**From:** Watkins, Robert  
**Sent:** Wednesday, March 16, 2022 9:34 AM  
**To:** mwolf@wolfjosey.com  
**Cc:** Werner, Jeffrey B  
**Subject:** March 2022 BAR Decision

BAR 22-03-01

1835 University Circle, TMP 060069000

Project: Landscaping

**PROPOSED POOL - Site Plan**  
 1835 University Circle  
 February 22, 2022

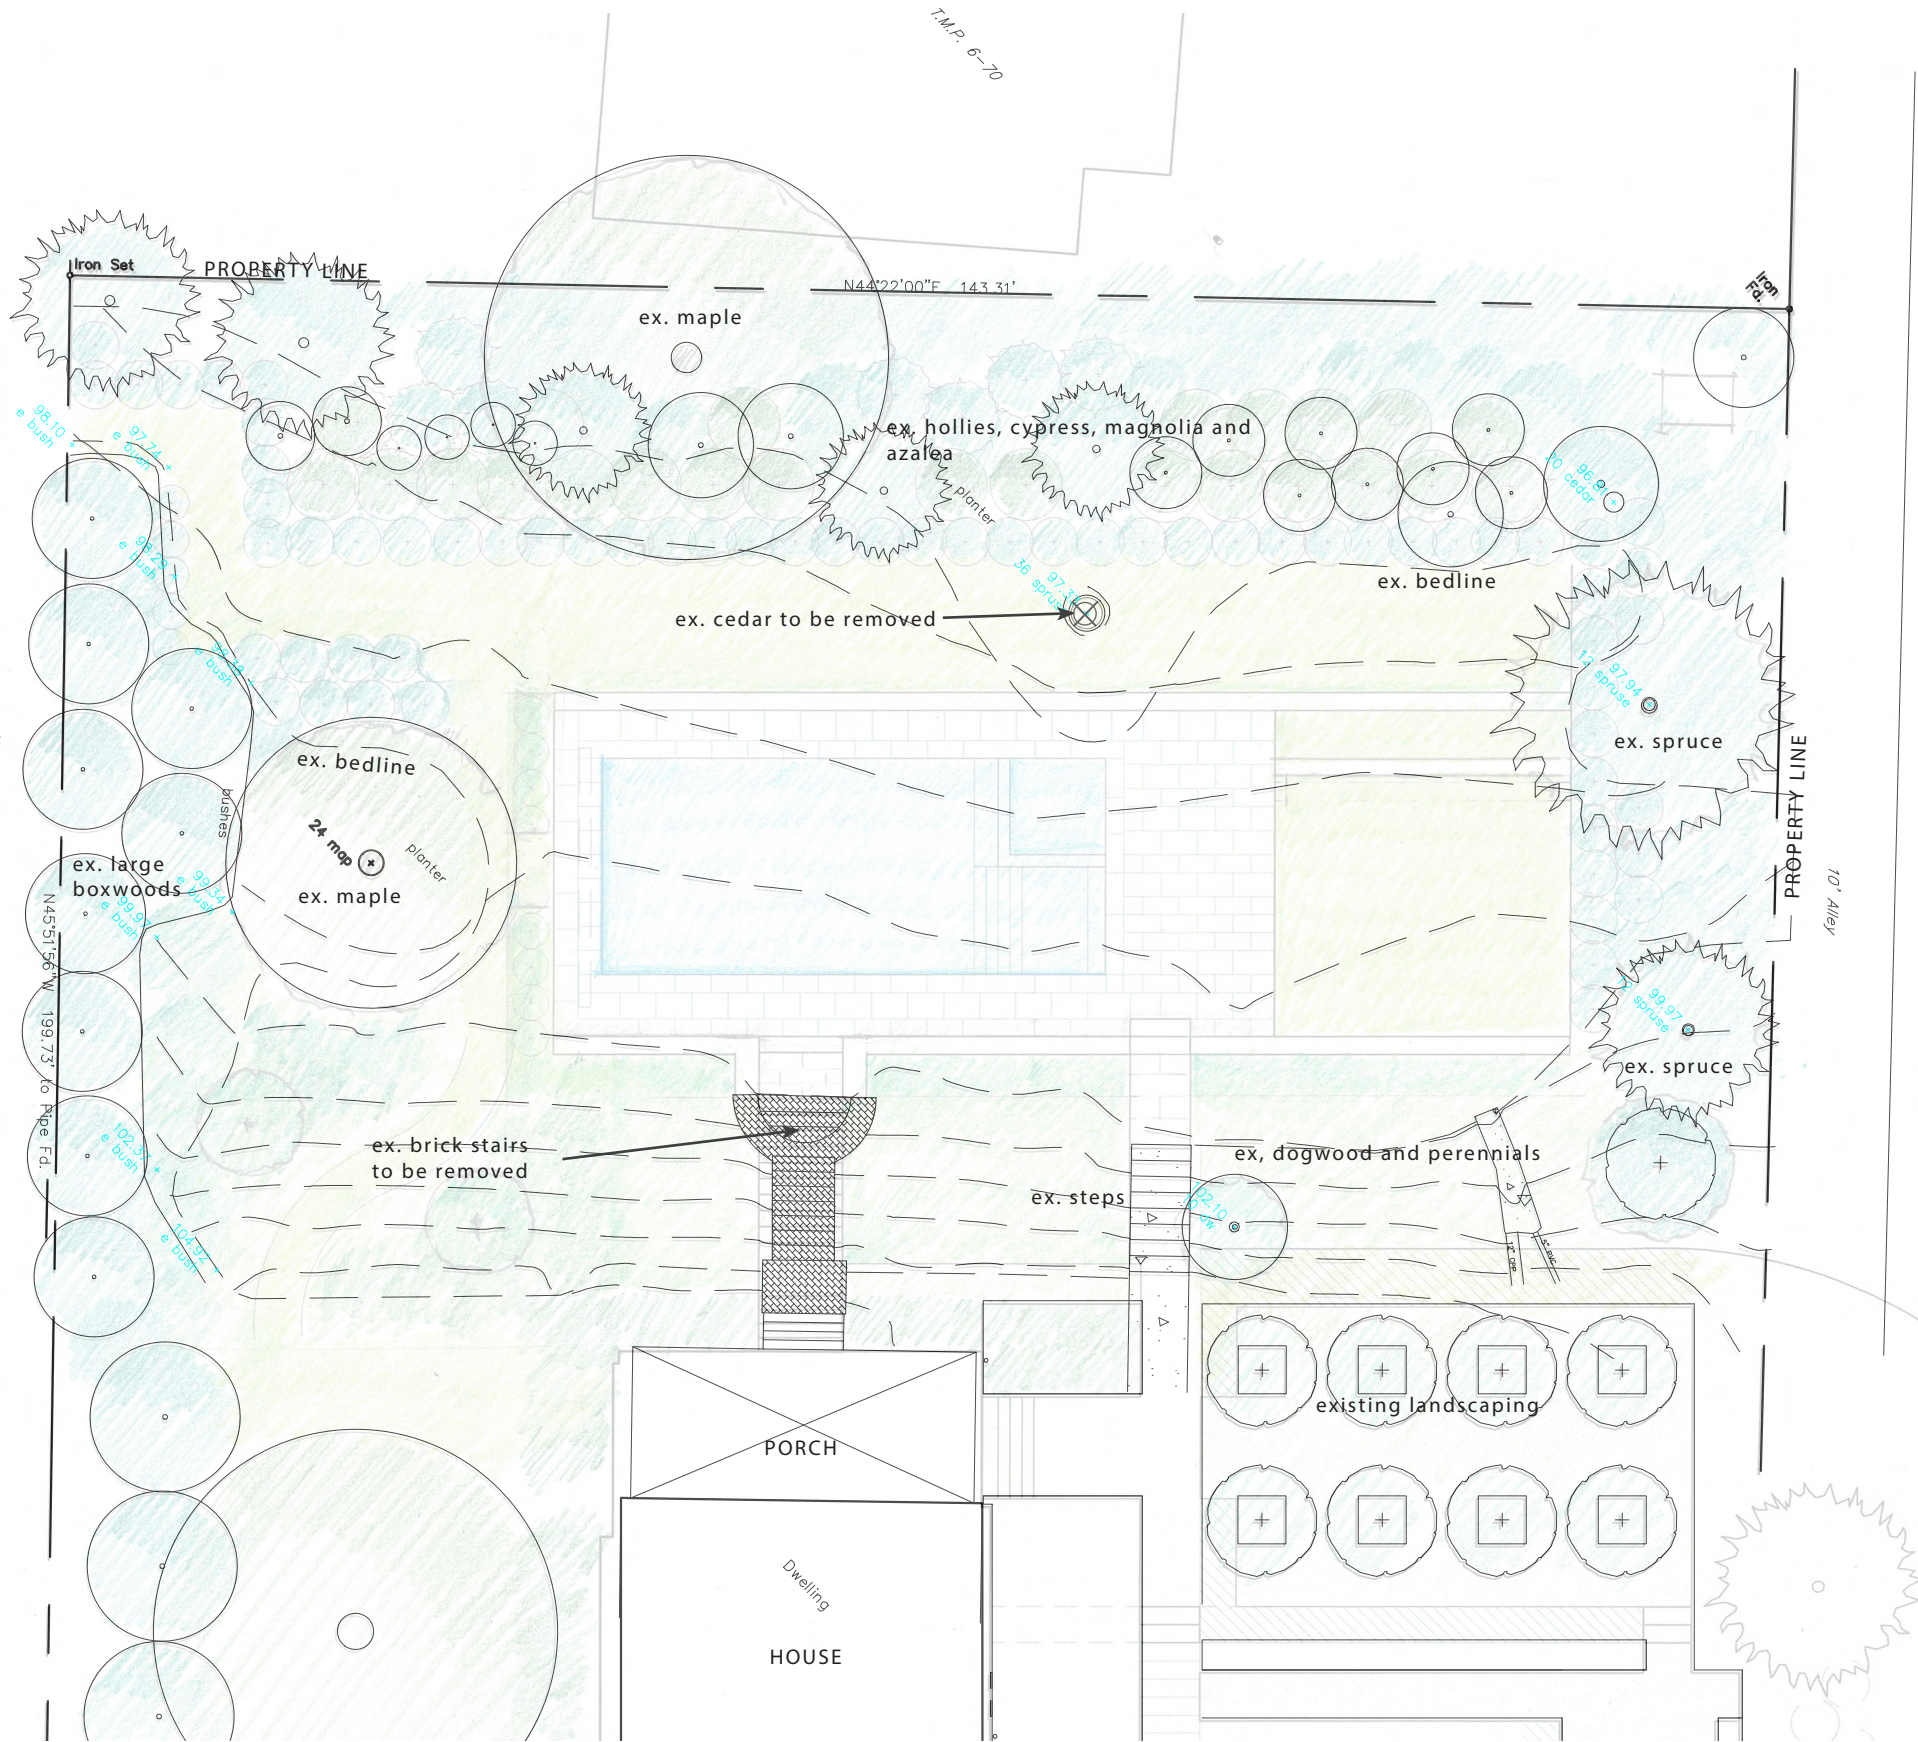
The west (side) yard is largely screened from the public right-of-way by large boxwoods along the University Circle property boundary. The design guidelines recommend that new outbuildings are placed behind dwellings but offer no such recommendation for pools. Given the proposed pool's minimal paving, muted palette, and boxwood buffer from the street, staff considers the siting in the side yard appropriate.

Staff finds that the material palette, scale, and proposed plantings of this landscape plan are consistent with other properties in the district. Based on the criteria in *Chapter II: Site Design and Elements* of the ADC District Design Guidelines, staff recommends approval, with a recommendation that the applicant consider adding an additional shade tree to compensate for the loss of the cedar tree.
